APPAREL PROMOTERS LTD.

Nasirabad, Rubi gate, Baizid Bostami Road, Chittagong, Bangladesh
(22.377522N, 91.815487E)

02nd Oct 2016

Lack of lateral stability of all single storey steel sheds

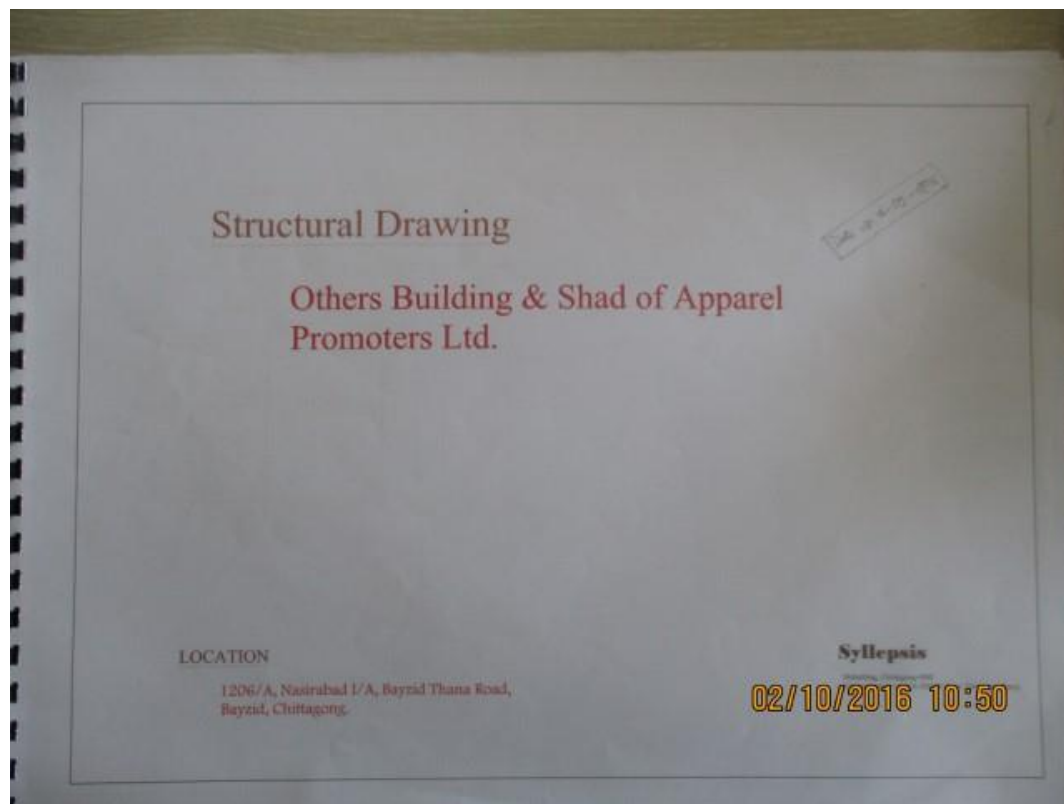
Weak connection between column & truss

Poor construction

Weak support of truss

No bracing observed

Lack of lateral stability due to poor connection detail and lack of bracing. The sheds are required to analysis of their stability system.
